November 8, 2019

Re: **Third Submission Review – Porteos** (Infrastructure CSP)  
Application Number: **DA-1903-13**  
Case Number: **2019-6032-00**

## Third Submission Review

**Figure I. Year 2040 Traffic Conditions**

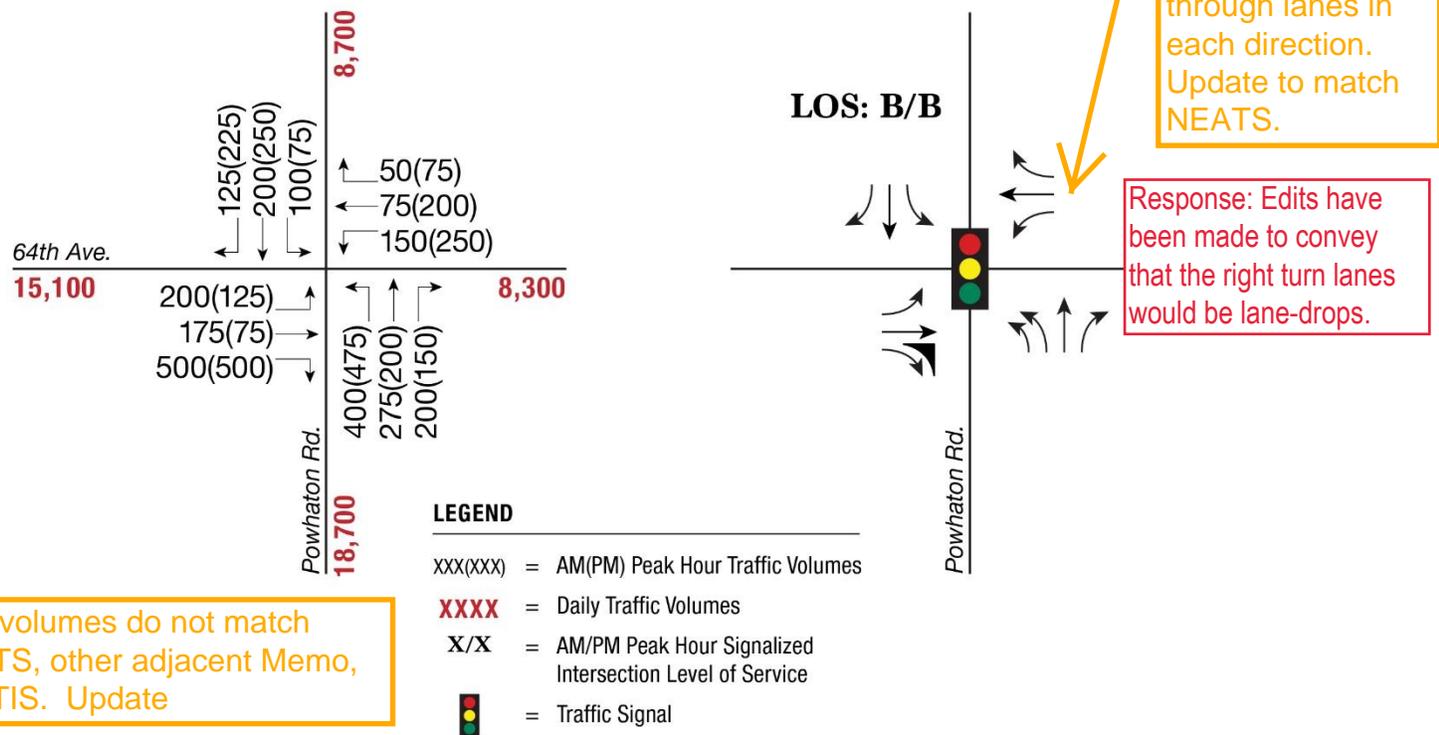
Comments 9.25.19:  
 A significant amount of previous comments were not addressed. They are as follows:  
 2) Explain more thoroughly what is meant by "blended" traffic forecasts? Was there a factor applied to each development? Were they added?

5) Provide justification for assumption of reduced volumes on 64th. Traffic Engineering has not received information that 64th extension to Monaghan Rd will not be completed.

6) Match NEATS Recommended Roadway network as identified in Figure ES-3 or otherwise produce a standard Traffic Impact Study with sufficient justification. NEATS is an approved area wide Transportation study that has been through a rigorous public process and deviations from this document would require a significant delay. This process has been requested for other areas of 64th and has resulted with a smaller section between only 2 roadways with a deferral of the additional laneage, and full ROW requirement.

- 1) Based on review of other submitted Memos in the area, 60th Ave between Jackson Gap St & Powhatan Rd is not anticipated to be part of the future roadway network. Ensure the 6,200 ADT trips are appropriately reallocated (& auxiliary lane needs reviewed/updated).
- 2) See comments throughout.

← Explain

Where is the new information?

Response: There is now better development information to help refine forecasts as compared to the time when the Master Porteos traffic study was prepared. We used this update knowledge AND NEATS results to refine the numbers. We have added some language to the new memo.

Response: Comment has been deleted.

Response: The numbers have been updated and refined. NEATS plays a significant role in the new numbers, and results shown here fall between NEATS 2040 projections and NEATS Build out projections. There is not an exact match, but projections here are in line with NEATS, much more so than the older Master study. With each study having its own unique "focus", variations in projections will result.

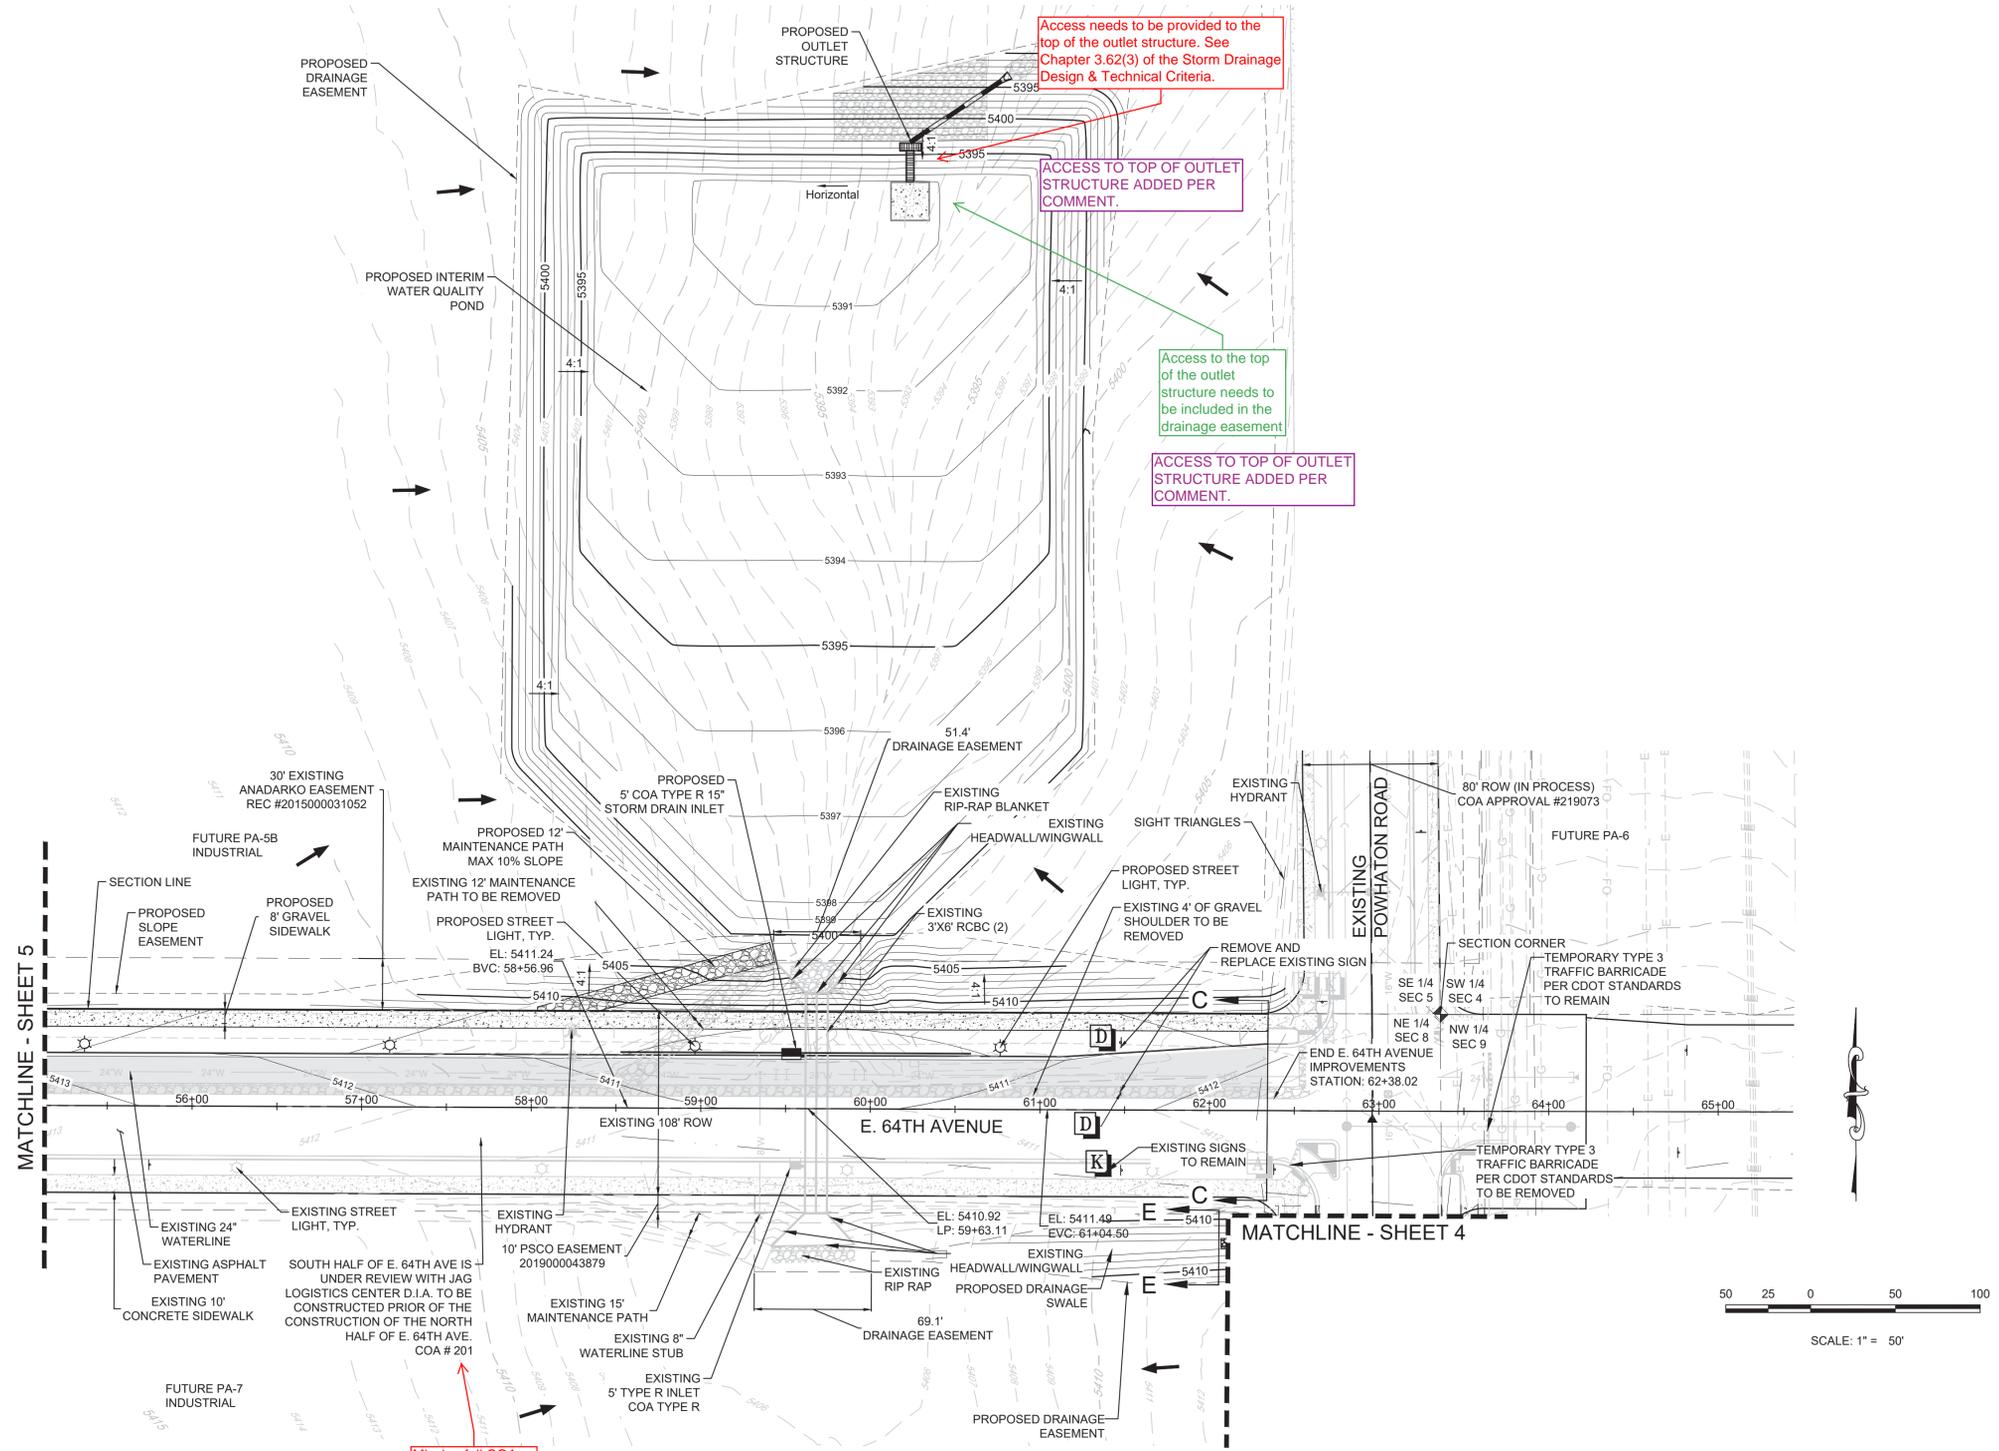
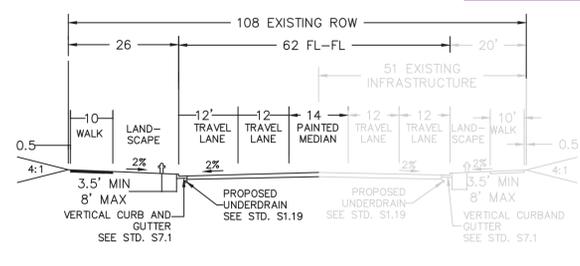
5A. Sheet 4 – Advisory comment. On civil plans label pressure zones on each side of the PRV.

Advisory Comment: On civil plans label pressure zones on each side of the PRV.

**Response: Acknowledged. Zone label has been added to civil plans.**

Comment received and Confirmed

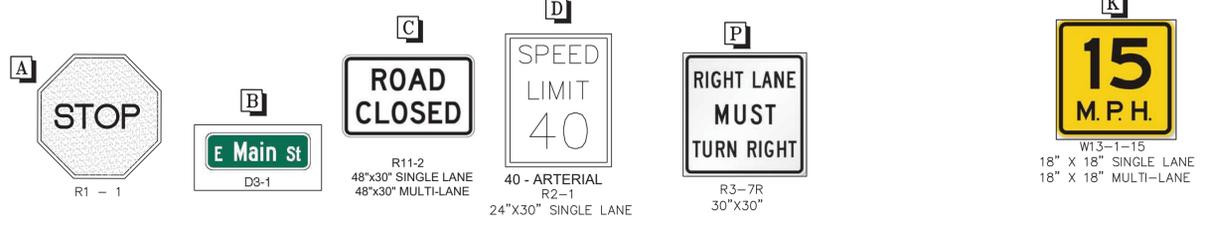
2C. Sheet 6 – Access to the top of the outlet structure needs to be included in the drainage easement.

5B. Sheet 6 – Access needs to be provided to the top of the outlet structure. See Chapter 3.62(3) of the Storm Drainage Design & technical Criteria. The sheet is missing the full COA approval number.

**Response: Access to outlet structure provided per comment.**

**Response: Access to outlet structure has been added per comment.**

**C** LANDSCAPE PLAN SCALE: 1" = 30'

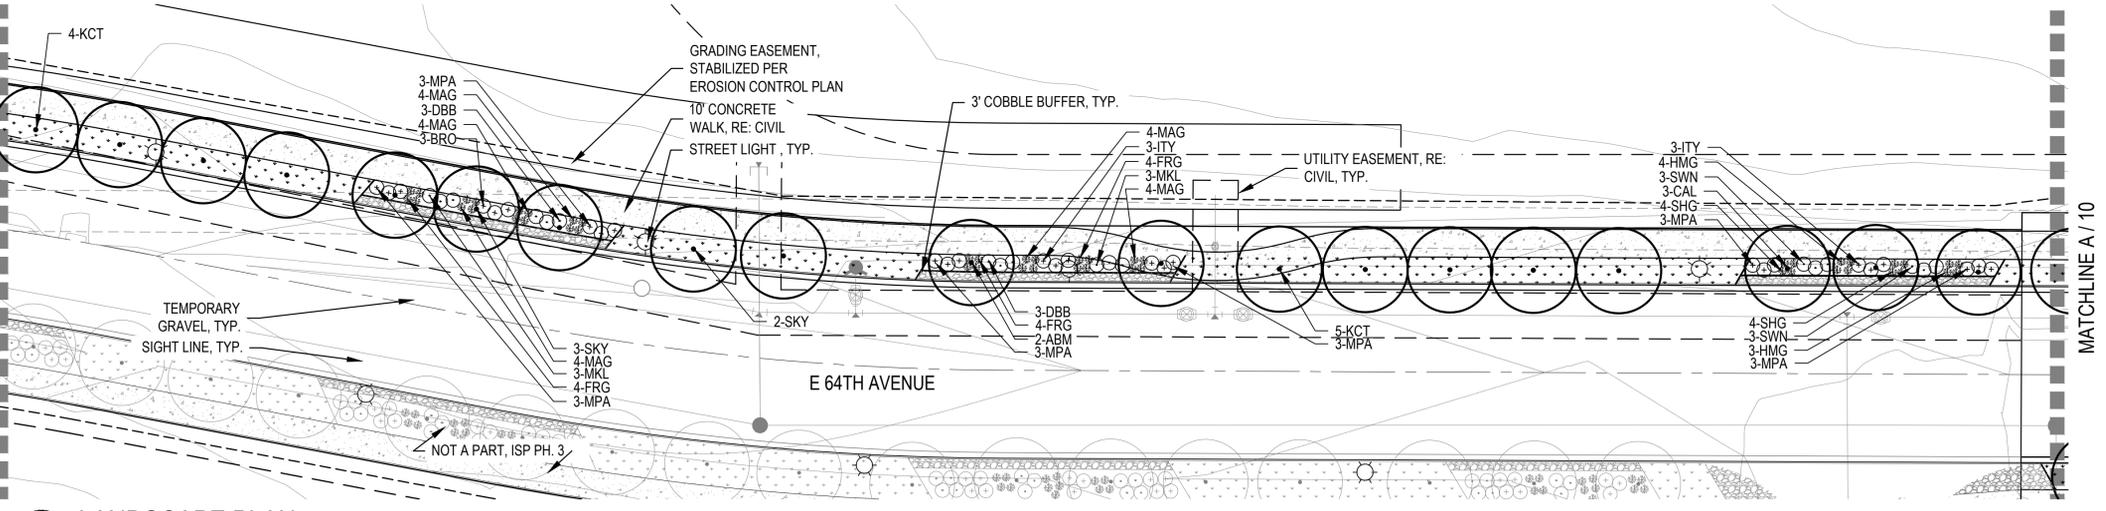
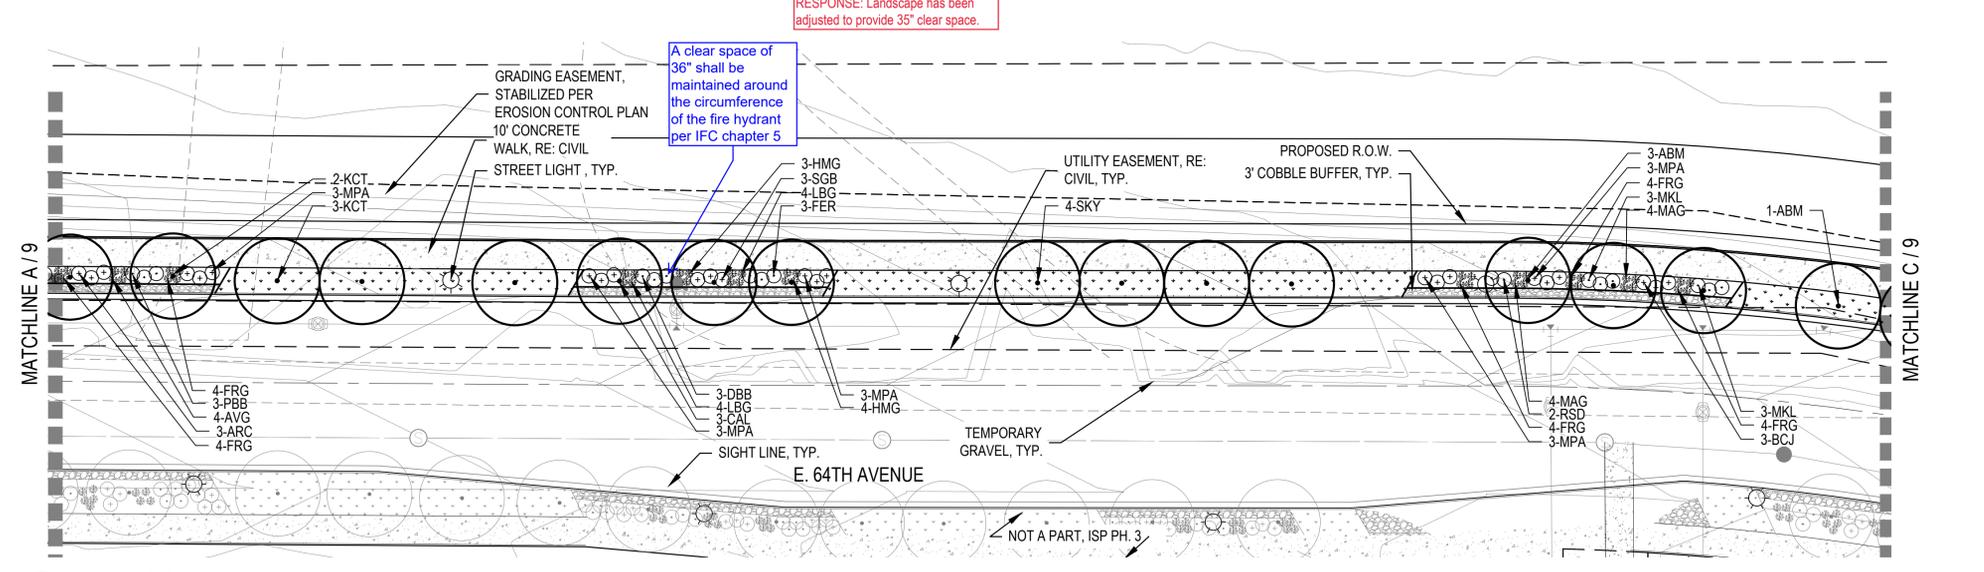
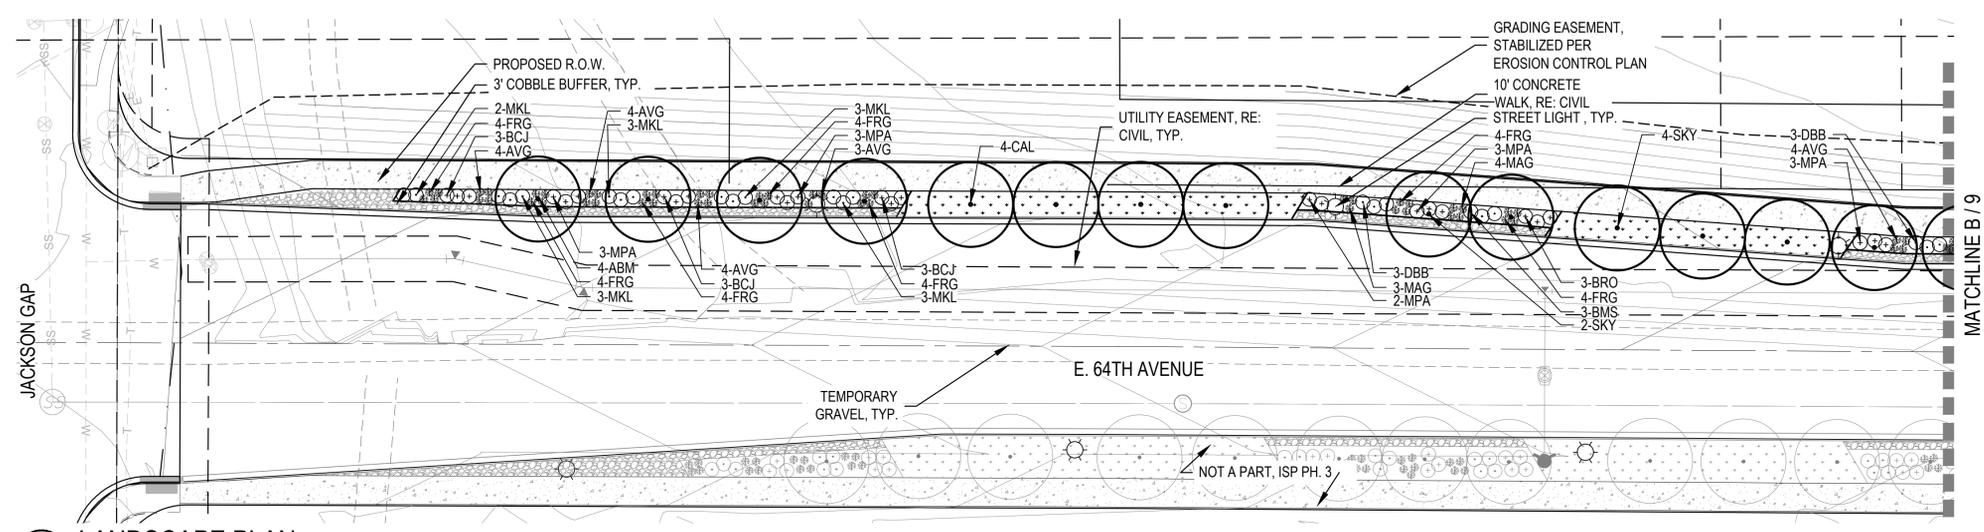
- A clear space of 36" shall be maintained around the circumference of the fire hydrant.

A clear space of 36" shall be maintained around the circumference of the fire hydrant per IFC chapter 5

**Response: The landscape has been revised to maintain a clear space of 36" has been maintained around the circumference of the fire hydrant.**

**RESPONSE:** Landscape has been adjusted to provide 35" clear space.
